AEP:NRC:2054

Donald C. Cook Nuclear Plant Unit 2
ADDITIONAL INFORMATION REQUESTED BY NUCLEAR
REGULATORY COMMISSION BULLETIN 2001-01
(TAC NOS. MB2624 and MB2625)

Westinghouse Report WDI-RVHP-002

“D.C. Cook 2
Reactor Vessel Head Penetration Inspection
Final Report”

Time of flight results for penetration #32 at 325 degrees are shown in the figure below:

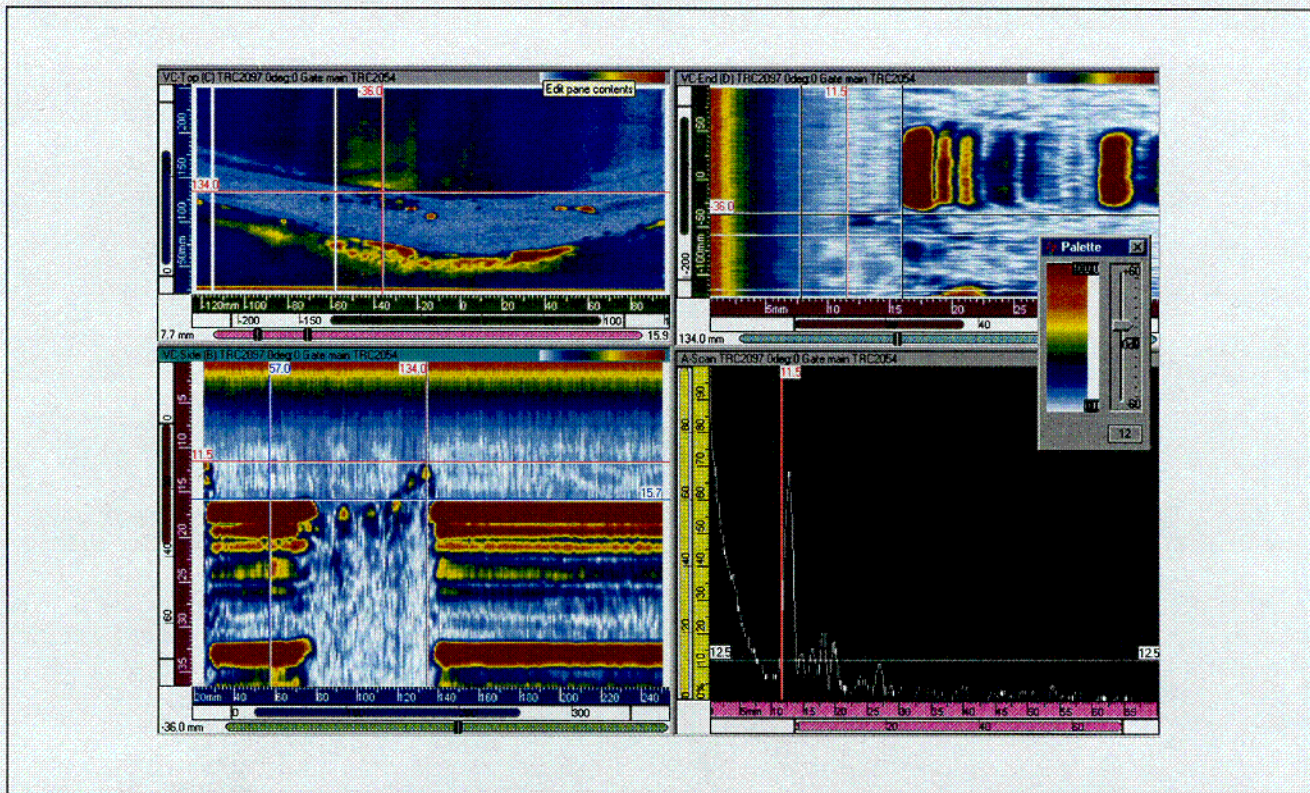
- The TOFD image shows 3 distinct reflectors at approximately 114, 120 and 127mm (4.48", 4.72" and 5.00") axial position which gradually increase from ~1mm to 4.2mm (~0.04" to 0.17") in depth from the backwall. The end view shows they have an extent of some 15°.
- The amplitude of the indication(s) is relatively high suggesting the source(s) to be volumetric in nature.
- Two other reflectors are apparent along the weld fusion line at lower axial elevations having similar characteristics.
- The TOFD results show the top of weld at the indication location is 132 mm (5.2 in.), 5.0mm (0.20") above the uppermost reflector. The reflectors are not above the weld.

Straight beam results for penetration #32 at 324 degrees are shown in the figure below:

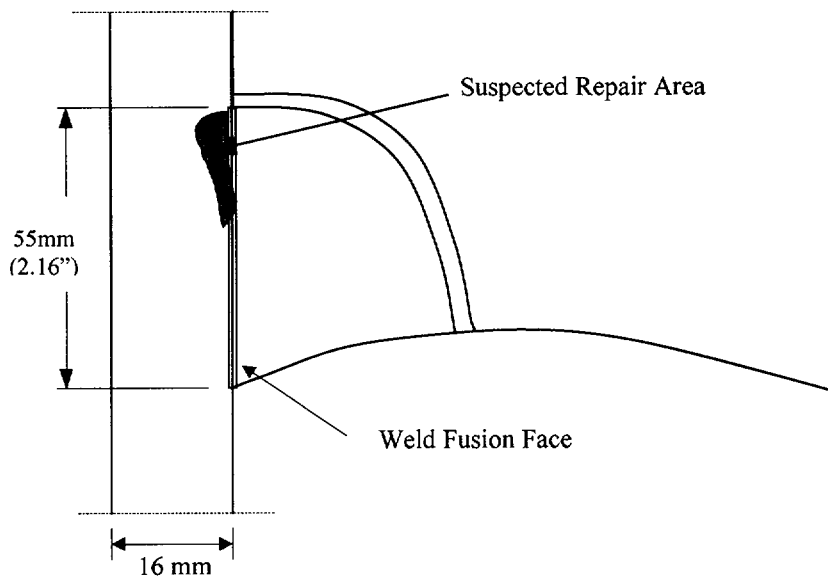
- The 0° image also shows 3 distinct indications above the interface that with correction for axial position from the recess appear to correspond almost exactly with those seen with TOFD. At this sensitivity level, we are unable to resolve responses from the bottoms of the 3 mm deep (0.12 in.) and 5.0 mm (0.20 in.) deep OD EDM notches in the calibration standard, indicating relatively large reflecting areas.
- The presence of these indications again suggest the source(s) to be more volumetric in nature.
- The two reflectors along the fusion line have similar characteristics in terms of amplitude and shape.
- The straight beam results show the top of weld at the indication location is 138 mm (5.4 in.), 4.0mm (0.16 in.) above the uppermost reflector. The reflectors are not above the weld.

These reflectors are more likely attributed to a possible repair area, with regions of incomplete fusion, rather than discreet planar reflectors with circumferential extent. This assessment is shown in the figure below:
